DOCUMENT: 160201A REV01

Erosion Prevention & Sediment Control Plan

**Bridge Replacement Route TH 14 Class III Bridge No. 26
Stamford, VT
VTrans STP 1441(29)**

ADDENDUM NO.1: Address Reviewer Comments dated March 30, 2016

Project Name and Address
**EROSION PREVENTION
 & SEDIMENT CONTROL**
GENERAL PLAN

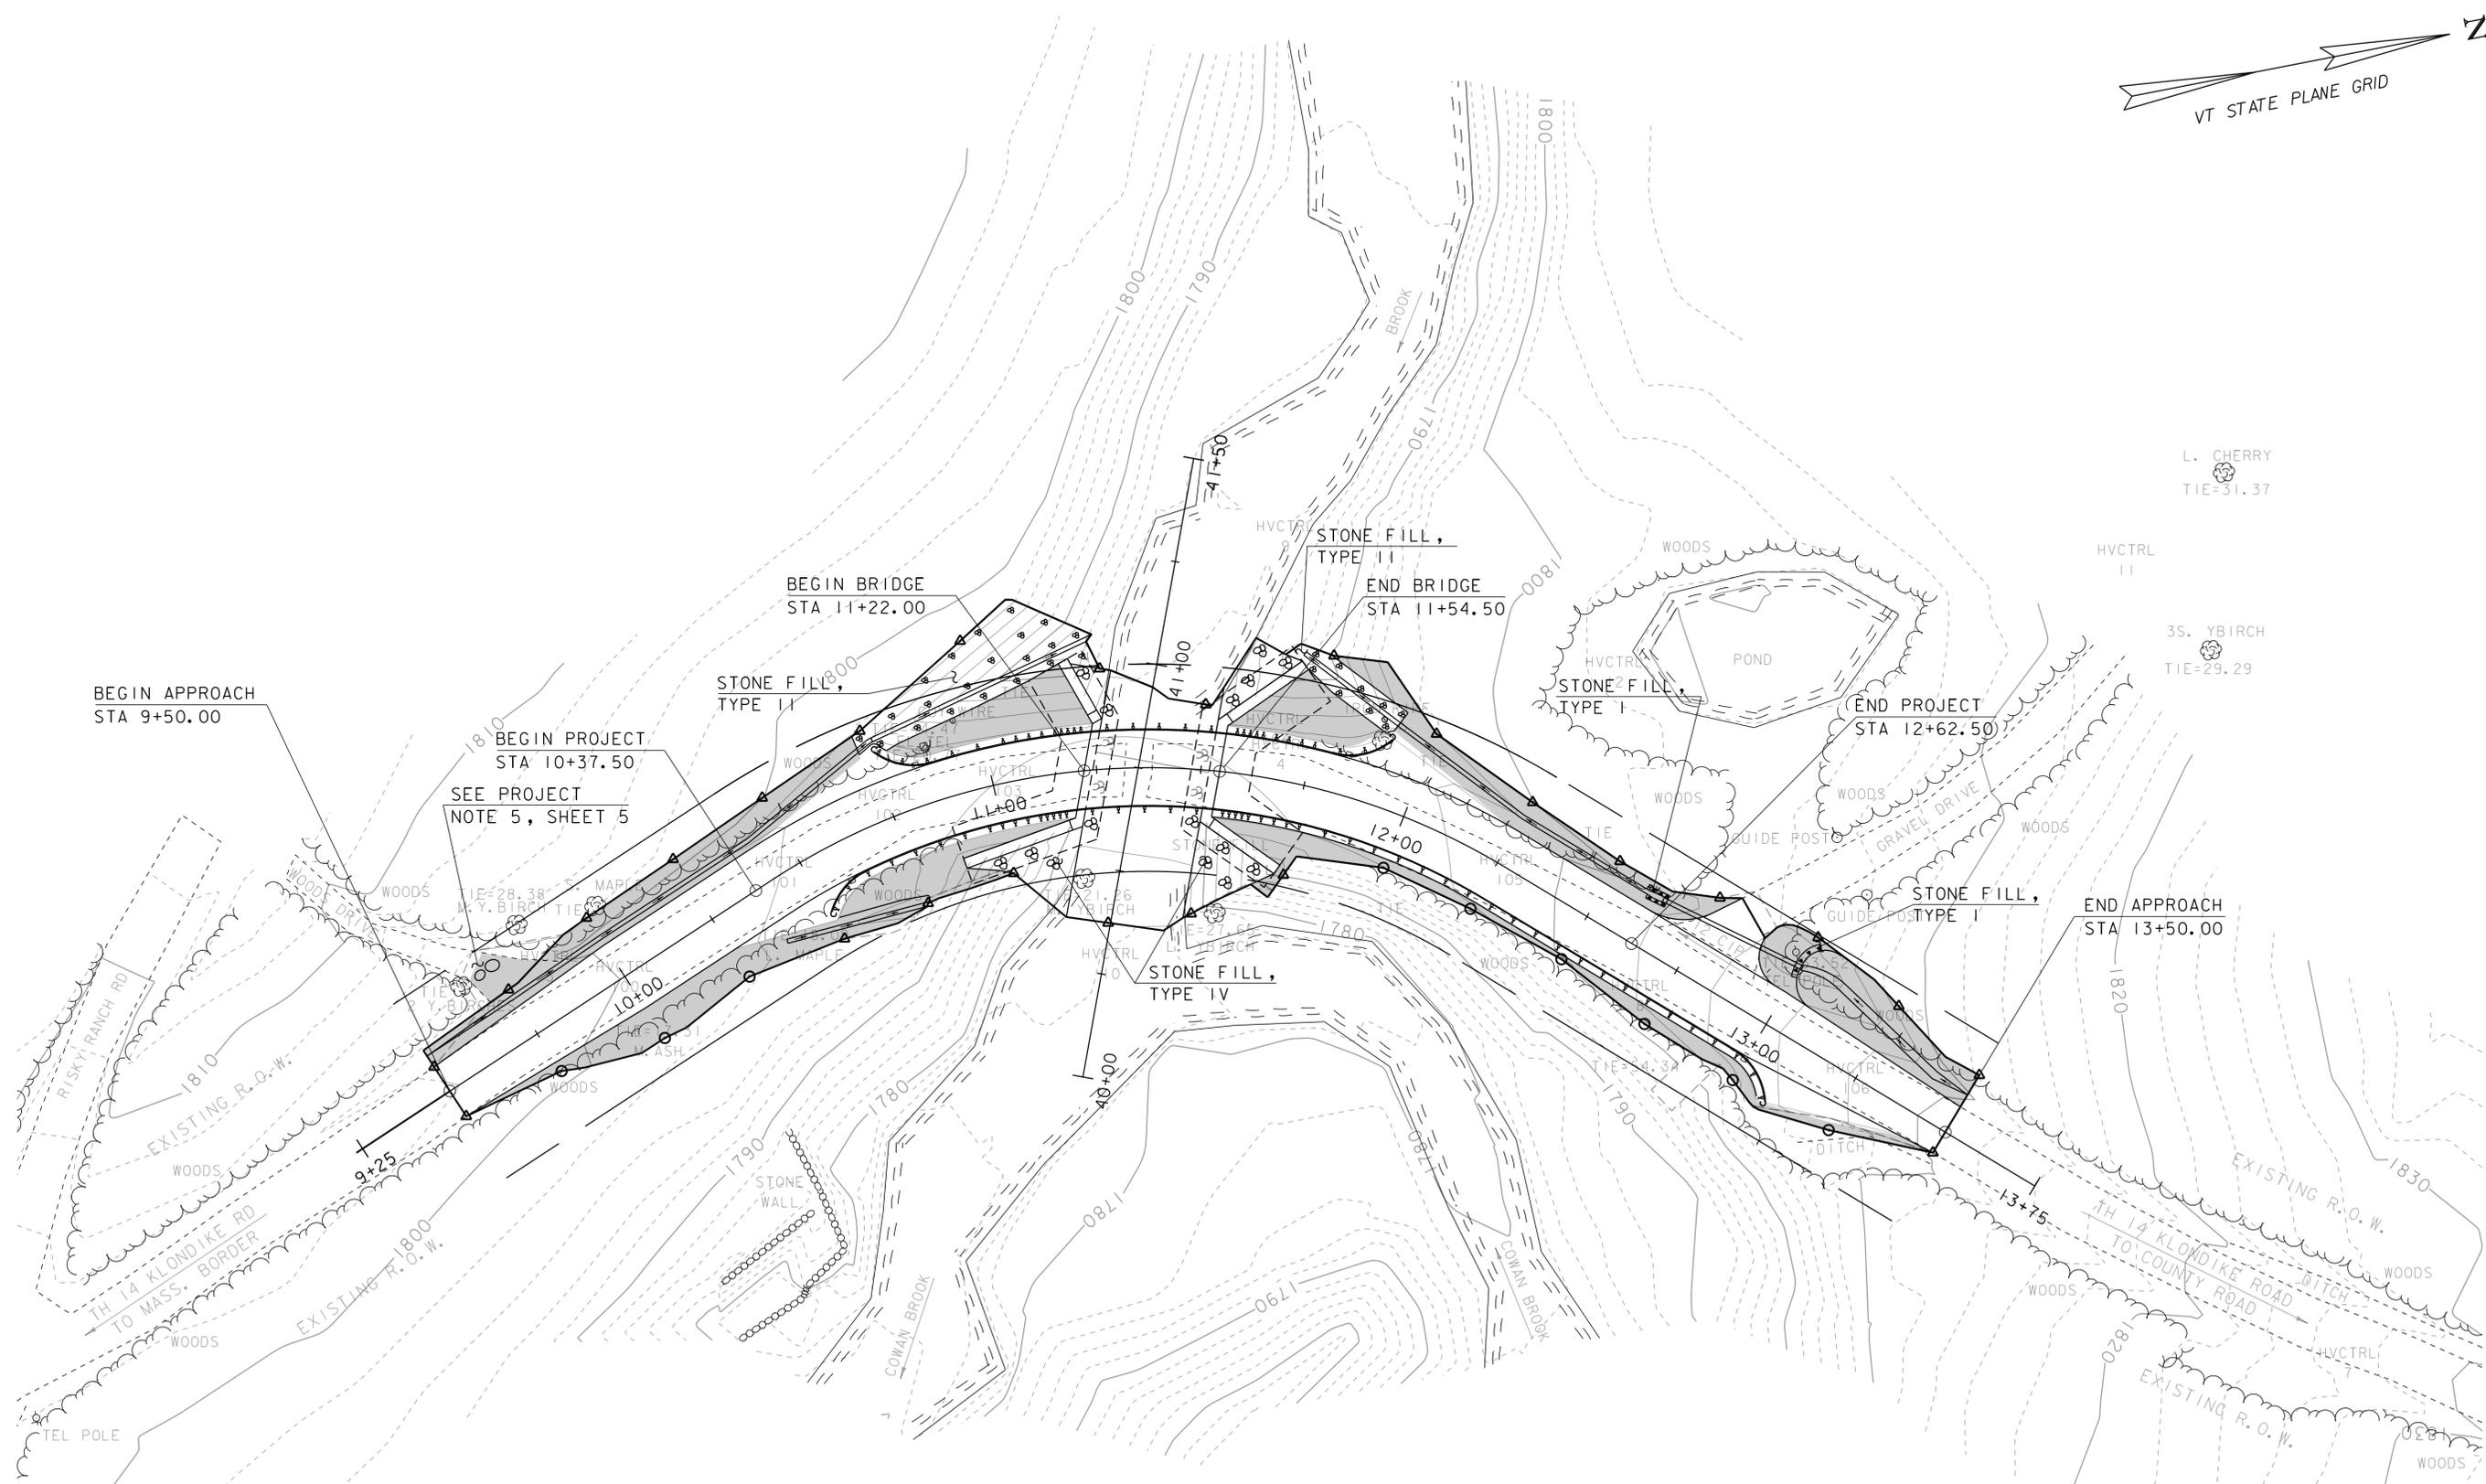
Please update this plan to include info from Water control plan, such as dewatering area.
Also include:
-Revised EPSC measures (BF, PDF, Silt fence (regular or WW) associated with the expanded disturbance areas
-Proposed stabilization measure for expanded surfaces? Stone, matting, etc.

DISTURBED AREA IN ADDITION TO CONTRACT EPSC PLAN IS 0.119 ACRE FOR A TOTAL REVISED DISTURBED AREA OF 0.489 ACRES

RELOCATE TURBIDITY BARRIERS TYP
